BURRIS/WAGNON ARCHITECTS, P.A.

ADDENDUM NO. 2

Re: **Batson Finishes 3rd Floor**
University of Mississippi Medical Center
Jackson, MS
IHL #209-585

LVT Floor Pattern
NORTH

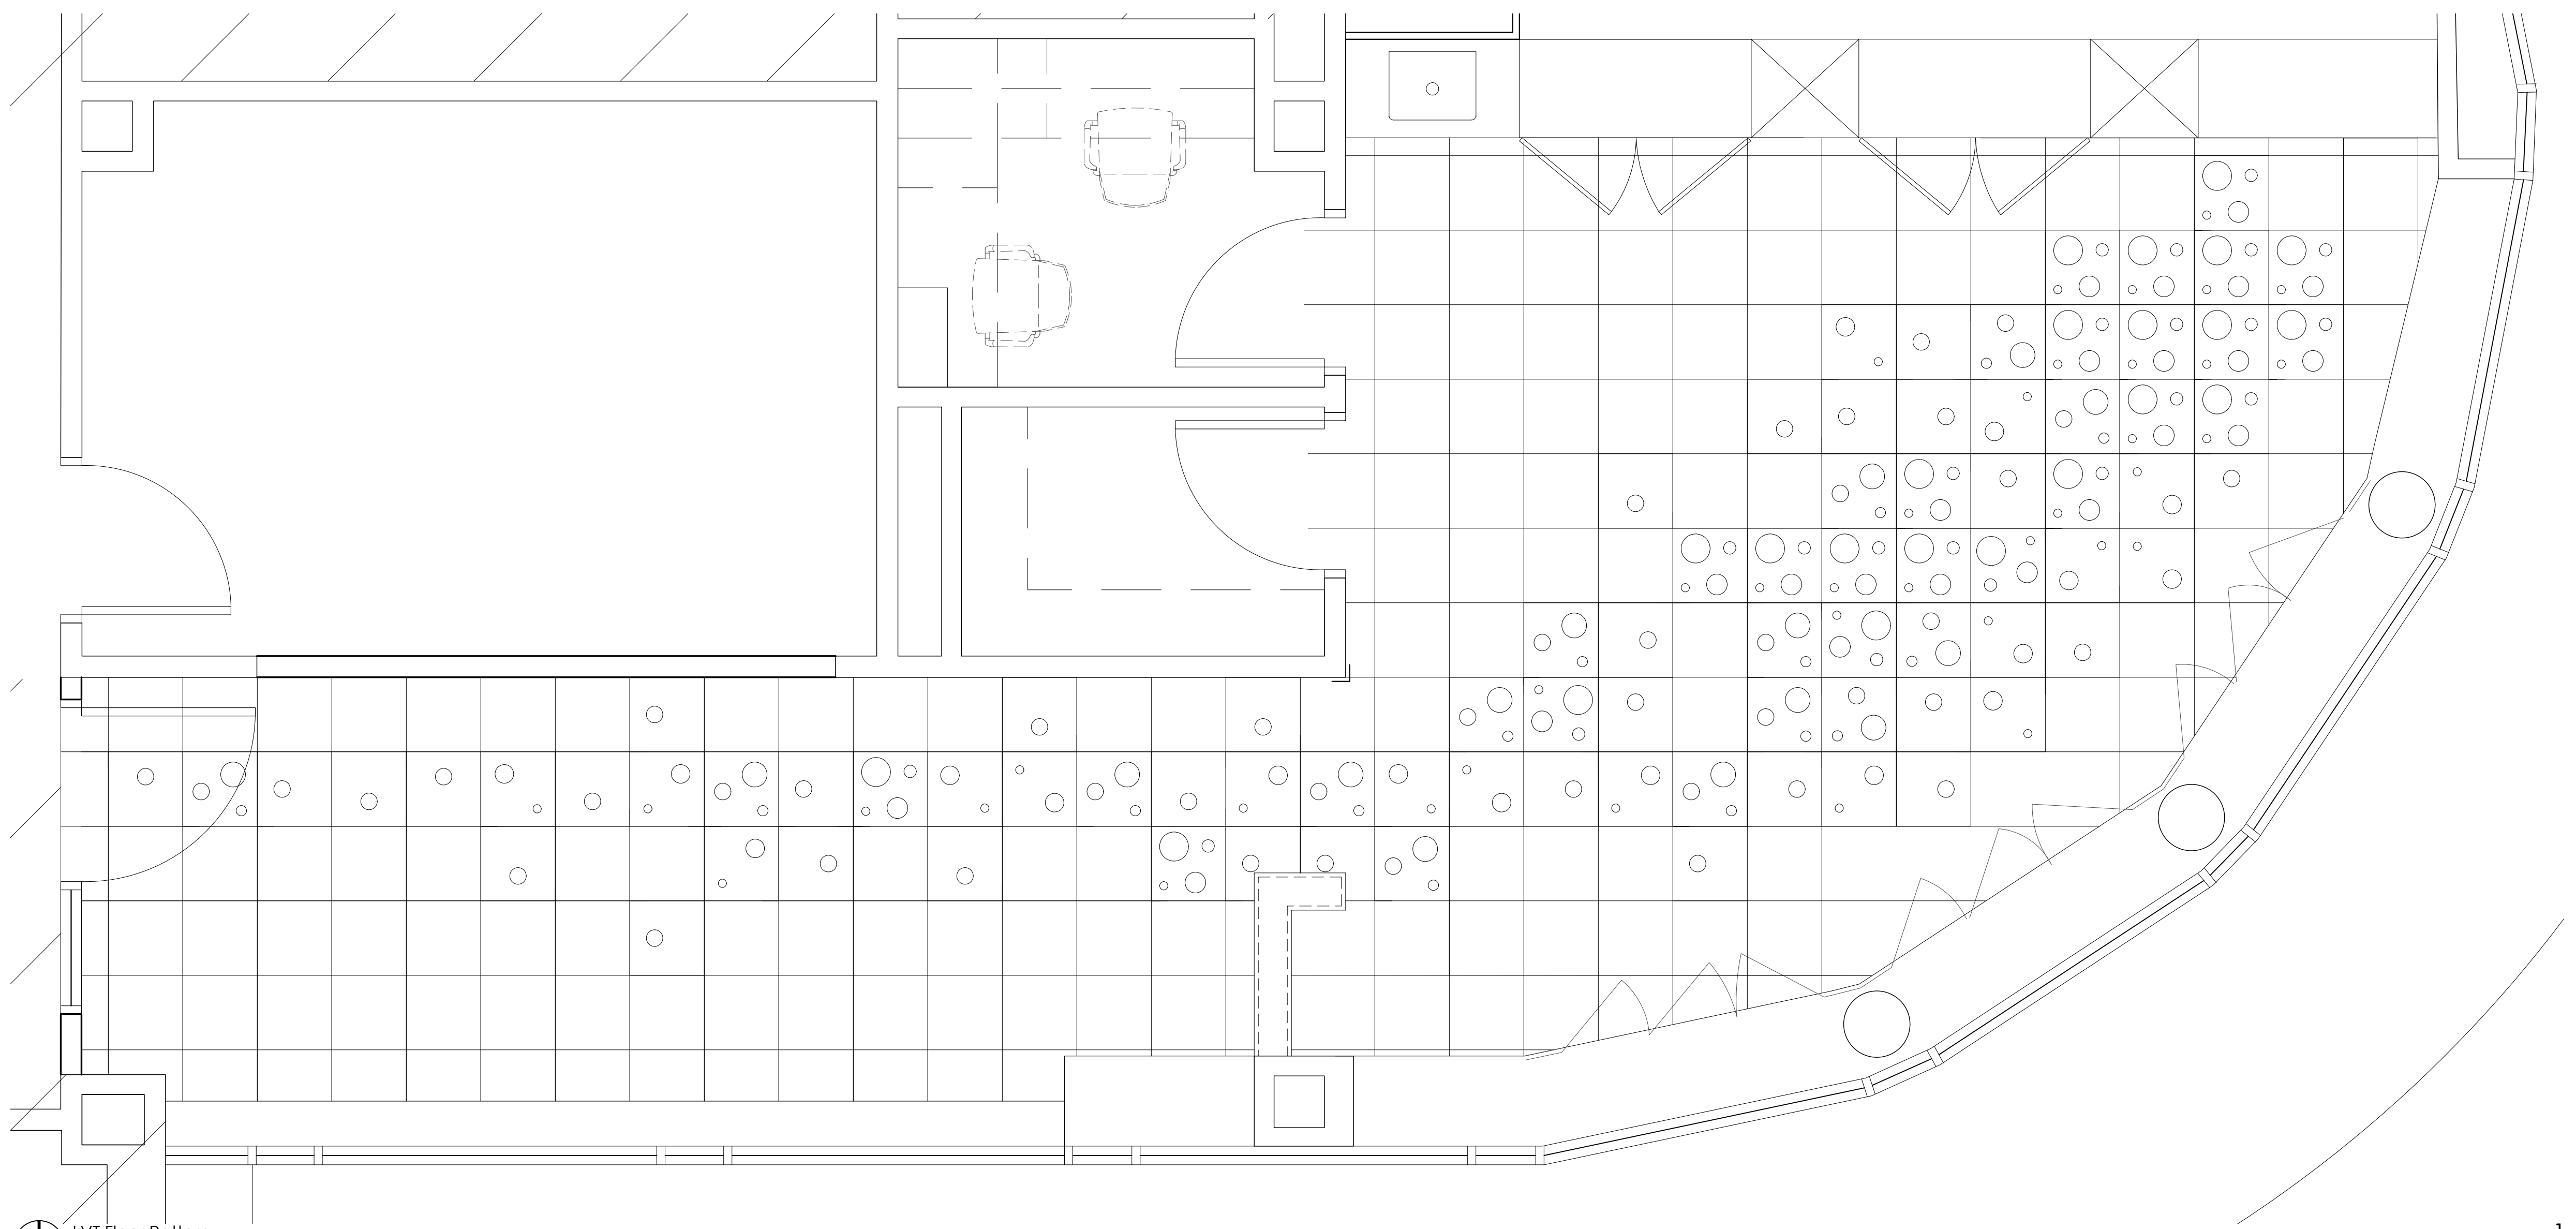
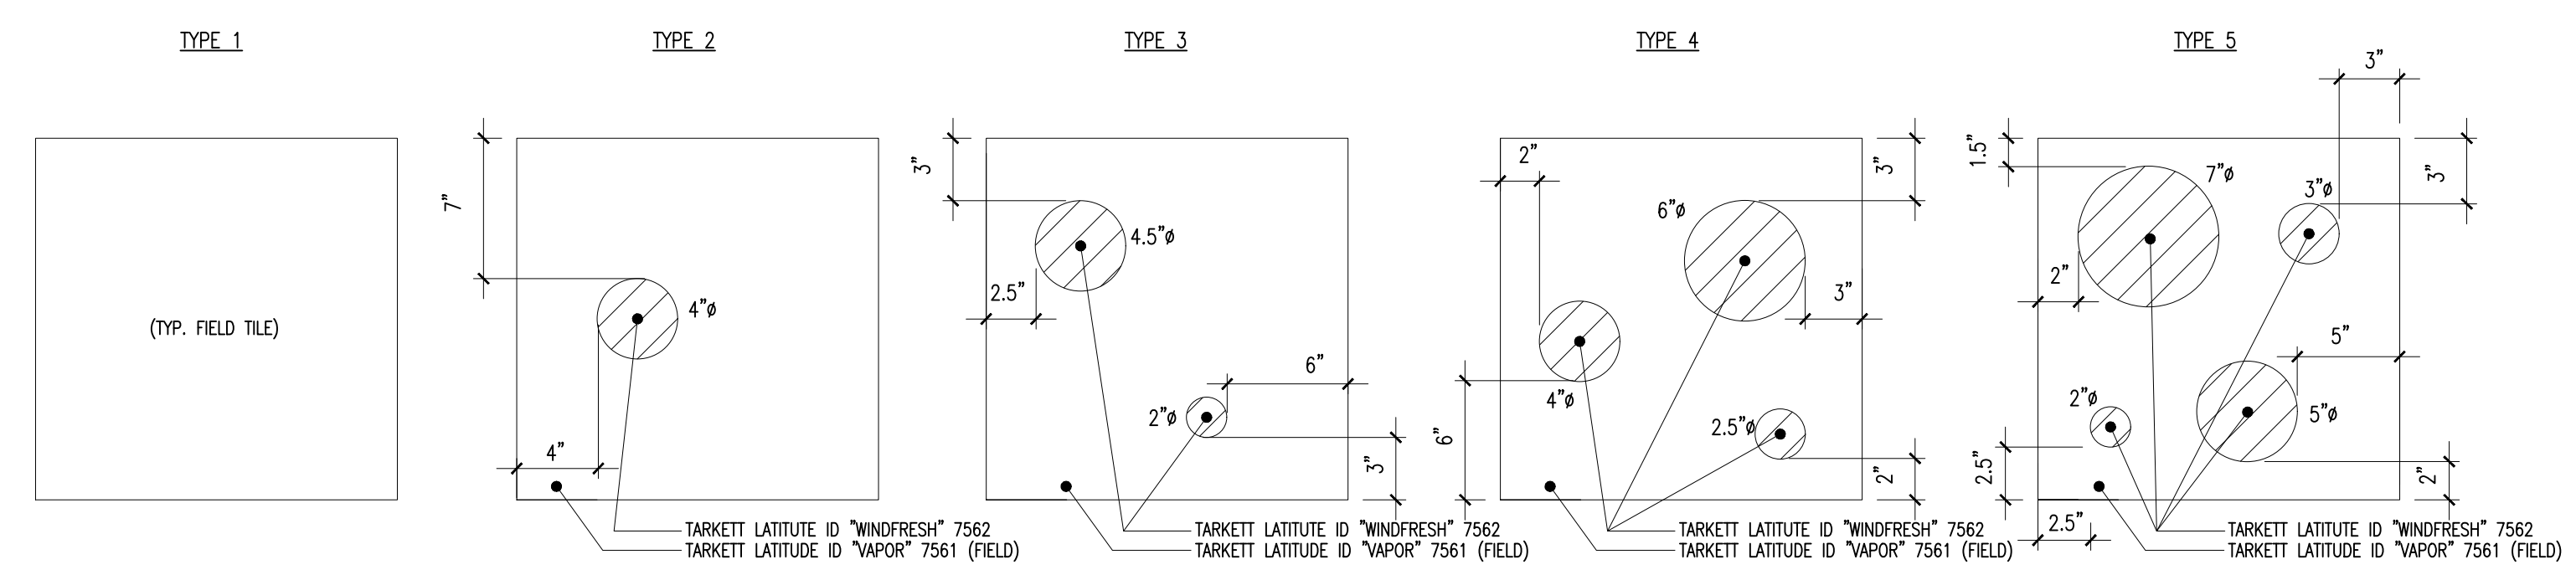
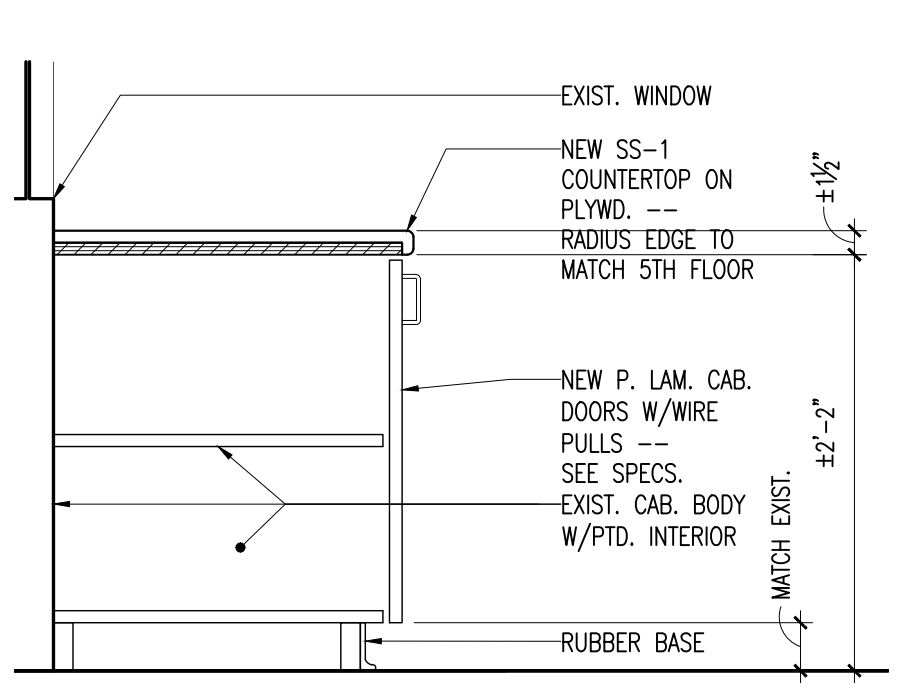
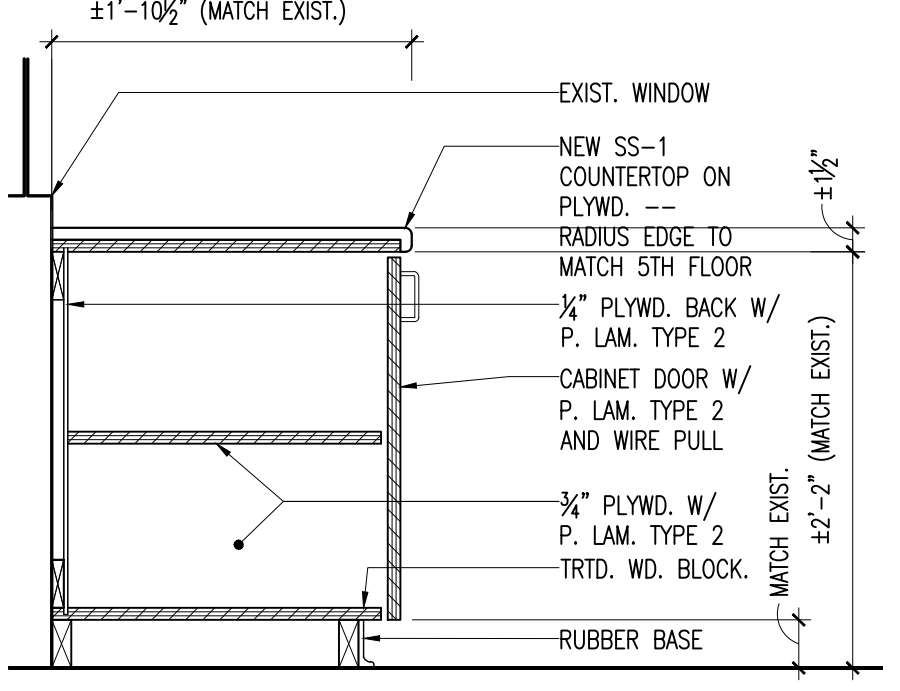
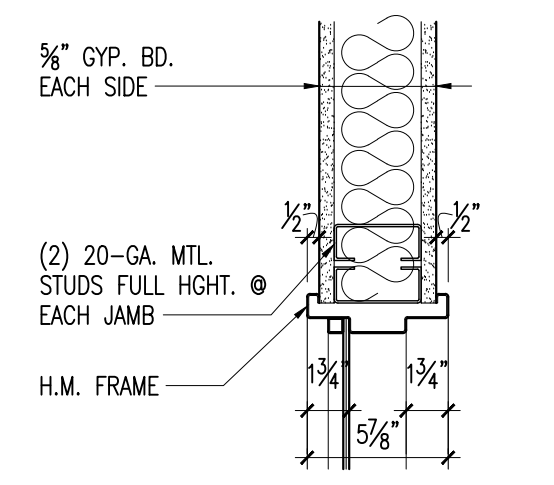
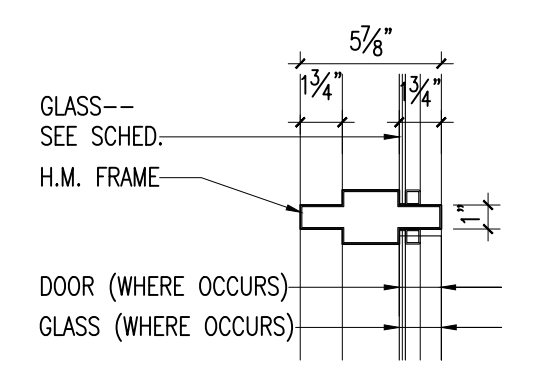
ADDENDUM #2
NOTE: ALL WORK THIS SHT. COMPRISES ALT. #2

BATSON - THIRD FLOOR PLAN - HVAC DEMOLITION
SCALE: 1/8" = 1'-0"

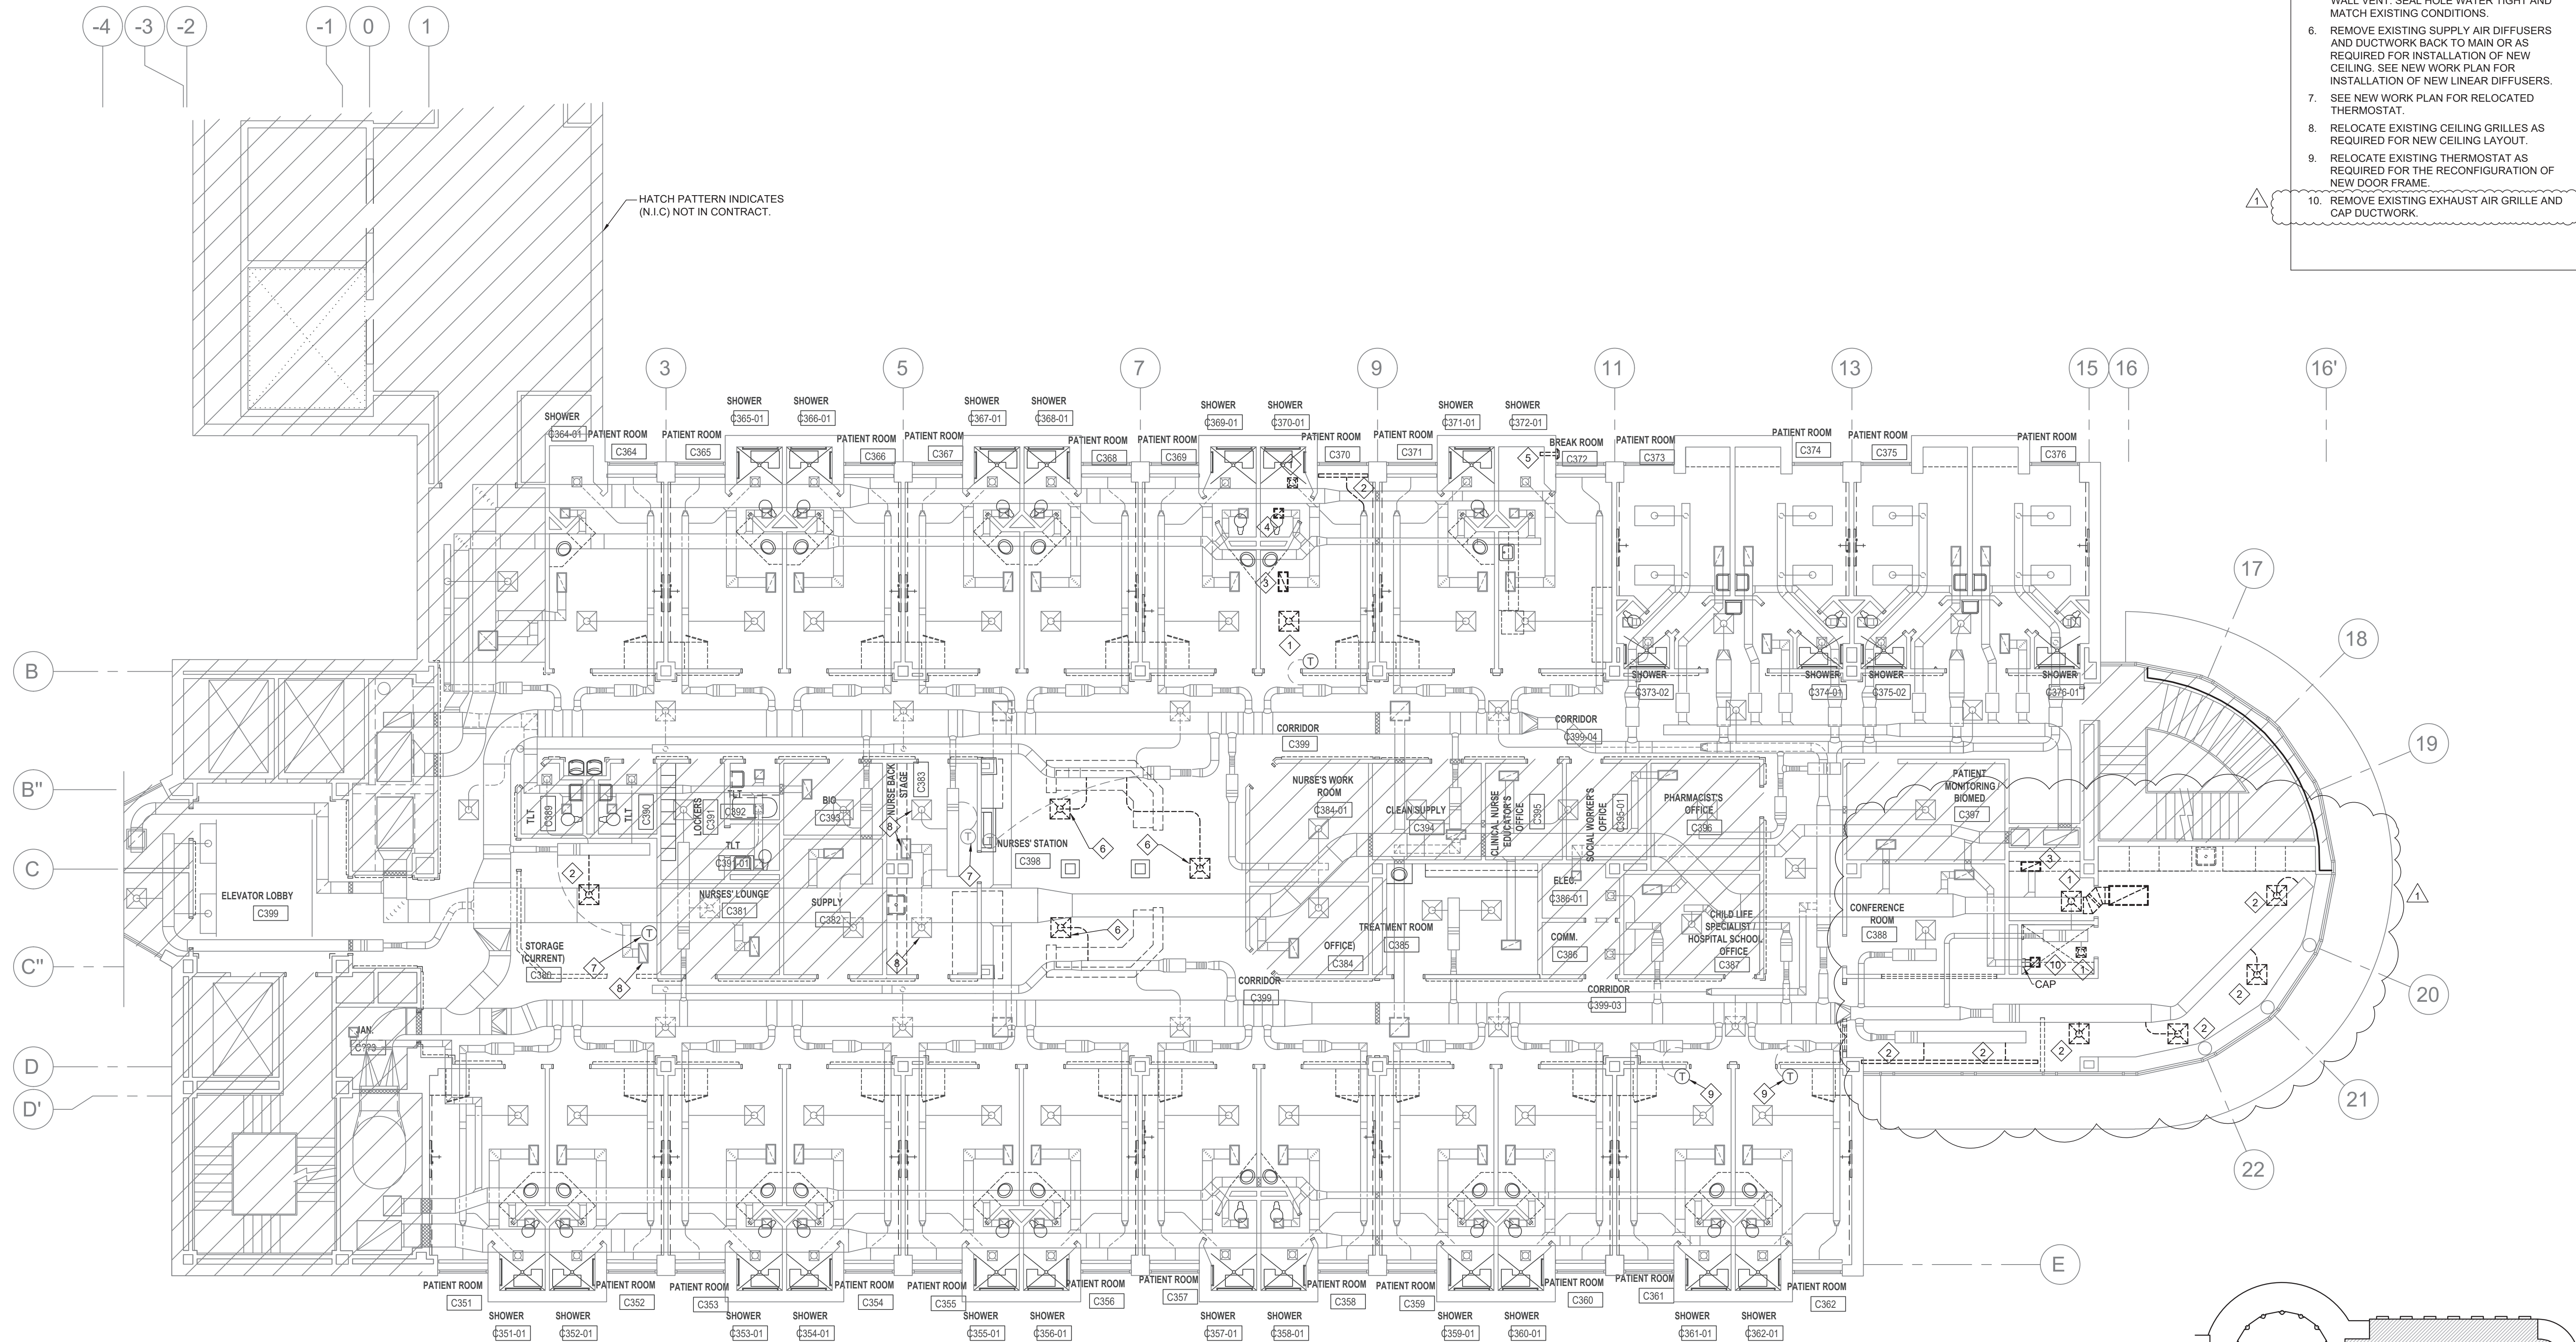
1. REMOVE EXISTING SUPPLY AIR DIFFUSER. SEE NEW WORK PLAN FROM NEW DIFFUSER INSTALLATION.
2. REMOVE EXISTING SUPPLY AIR DIFFUSER AND PORTION OF DUCTWORK BACK TO MAIN. SEE NEW WORK PLAN FROM NEW DIFFUSER INSTALLATION.

3. REMOVE EXISTING RETURN AIR GRILLE. SEE NEW WORK PLAN FROM NEW GRILLE INSTALLATION.
4. REMOVE EXISTING EXHAUST AIR GRILLE. SEE NEW WORK PLAN FROM NEW GRILLE INSTALLATION.

5. REMOVE EXISTING DRYER EXHAUST DUCT AND WALL VENT. SEAL HOLE WATER TIGHT AND MATCH EXISTING CONDITIONS.
6. REMOVE EXISTING SUPPLY AIR DIFFUSERS AND DUCTWORK BACK TO MAIN OR AS REQUIRED FOR INSTALLATION OF NEW CEILING. SEE NEW WORK PLAN FOR INSTALLATION OF NEW LINEAR DIFFUSERS.

7. SEE NEW WORK PLAN FOR RELOCATED THERMOSTAT.
8. RELOCATE EXISTING CEILING GRILLES AS REQUIRED FOR NEW CEILING LAYOUT.
9. RELOCATE EXISTING THERMOSTAT AS REQUIRED FOR THE RECONFIGURATION OF NEW DOOR FRAME.

10. REMOVE EXISTING EXHAUST AIR GRILLE AND CAP DUCTWORK.

ADDENDUM #2
CLOUD COMPRISES ALT. #2
